Translation Digit Function Added

Category	S/W Release Version	Date
H.323	7.02	Feb. 2004

[Number Translation & Translation Digit]

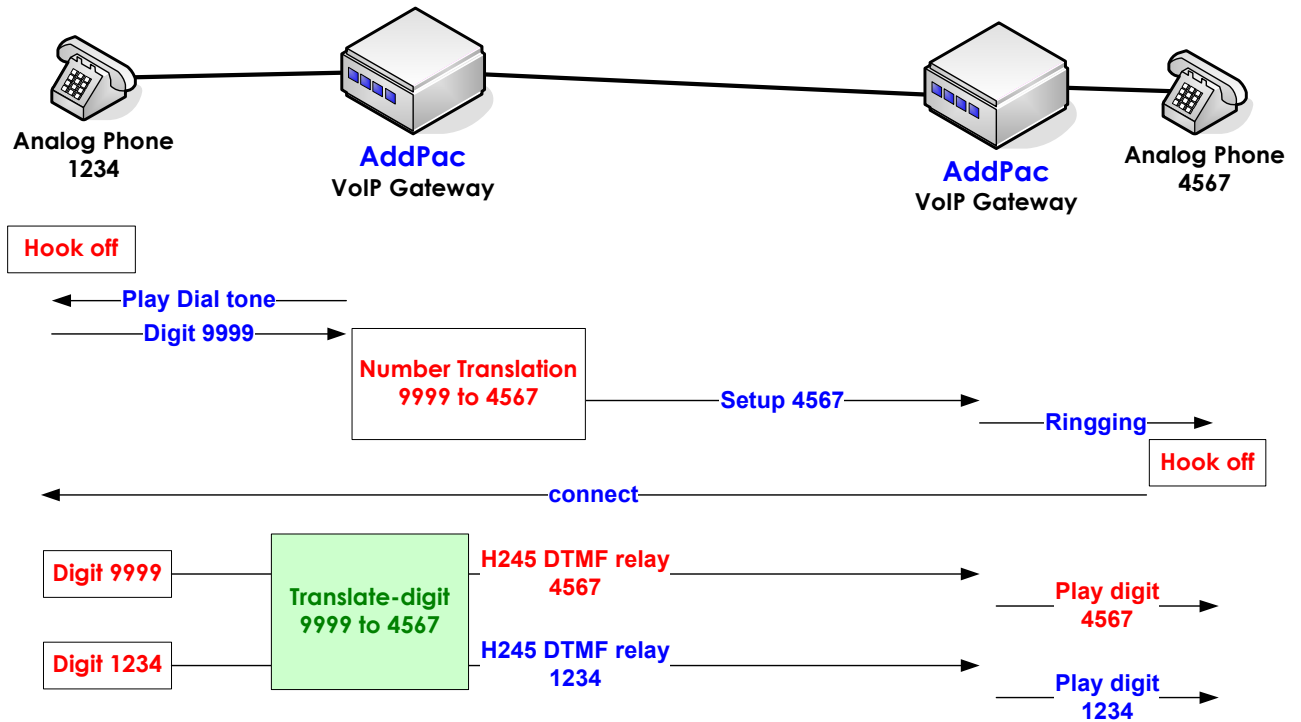
This feature translates the relayed digits (DTMFs) according to the configured rule during a call. It is different from Number Translation that changes the Calling Party Number or Called Party Number when establishing a call.

The above figure shows the difference between **Number translation** (translation-rule) and **translation-digit** commands. In case of Number Translation, the calling gateway is applied with a rule to change “9999” to “4567.” It is applied to the Called Party Number. Thus the rule changes the e.164 number of the Called party. When the same rule is applied to “translation-digit,” it changes DTMF relay digits. That is, it changes the DTMF number relayed during a call.
